Justification for the use of RAPTOR-M3G for the Catawba Unit 1
Measurement Uncertainty Recapture Power Uprate (MUR)
Fluence Evaluations

- Duke requested this meeting to present its written response to RAI SRXB-RAI 8.
- The RAPTOR-M3G code used to calculate fluence for MUR conditions does not appear to be approved by the NRC for generic application.
- This meeting coupled with additional technical information submitted to the NRC provides the justification for the use of RAPTOR-M3G for the Catawba Unit 1 MUR Power Uprate Fluence evaluations.

Catawba Unit 1 MUR SRXB-RAI 8 Response

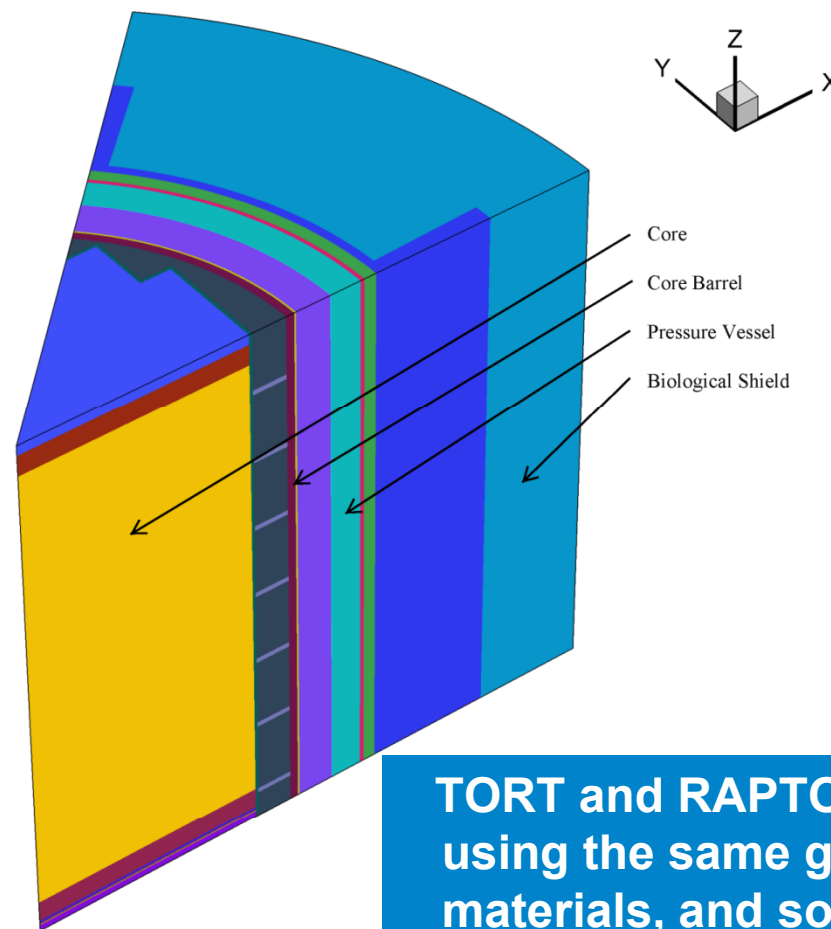
- MRE model – 209 radial, 195 azimuthal, and 85 axial mesh intervals

TORT and RAPTOR-M3G runs are using the same geometry model, materials, and source distributions

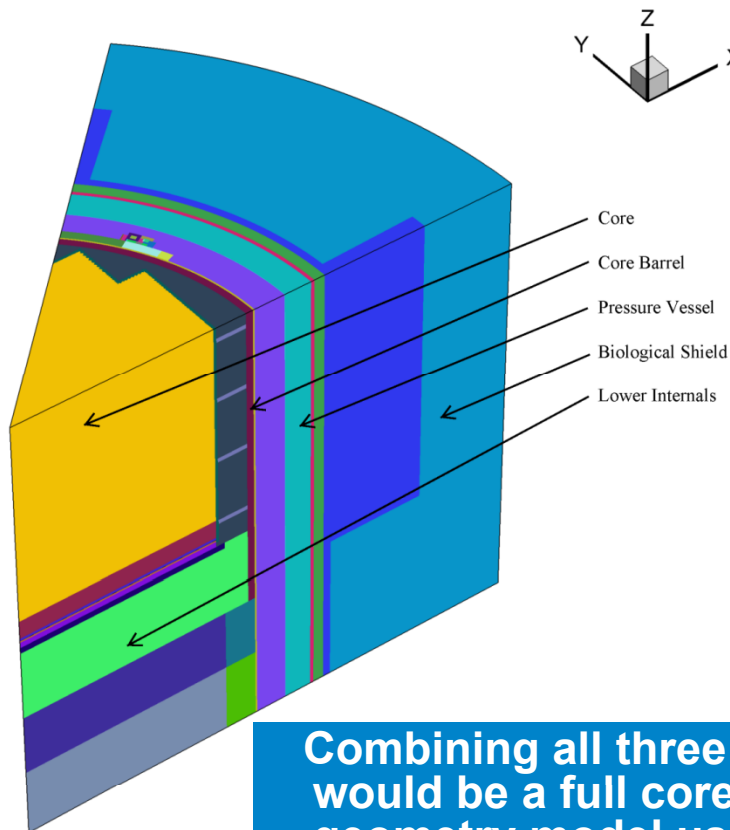
- LRE model – 209 radial, 195 azimuthal, and 91 axial mesh intervals

Combining all three reduced size models would be a full core model similar to geometry model used in WCAP-17669-NP, but still not as refined.
